Comments on the Gazebo project proposed by 8636 House owner Cui

8636 N MERCER WAY RESIDENCE SITE IMPROVEMENT

ENLARGED SITE PLAN

SHEET NO.
L-01

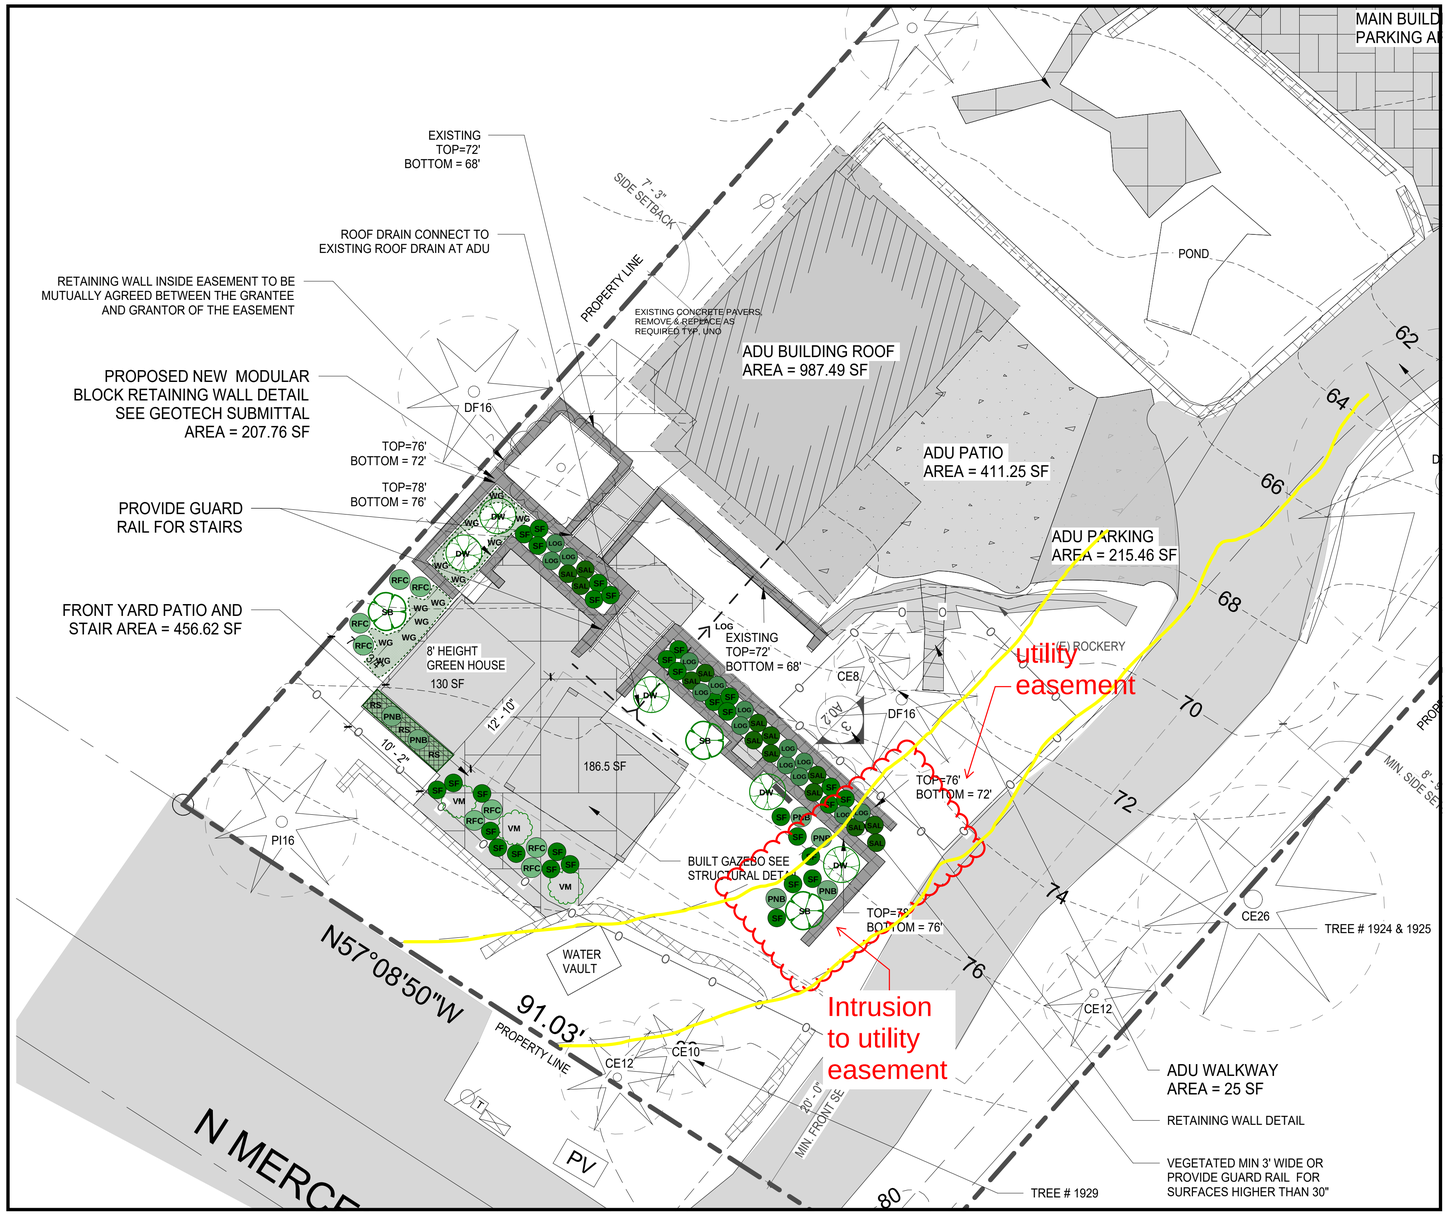
1. The retaining wall is still located within the utility easement, and I also noticed that several shrubs are positioned inside this area. As far as I understand, no structure—including a retaining wall—should be placed within a utility easement, as it would obstruct access for maintenance or emergency purposes.
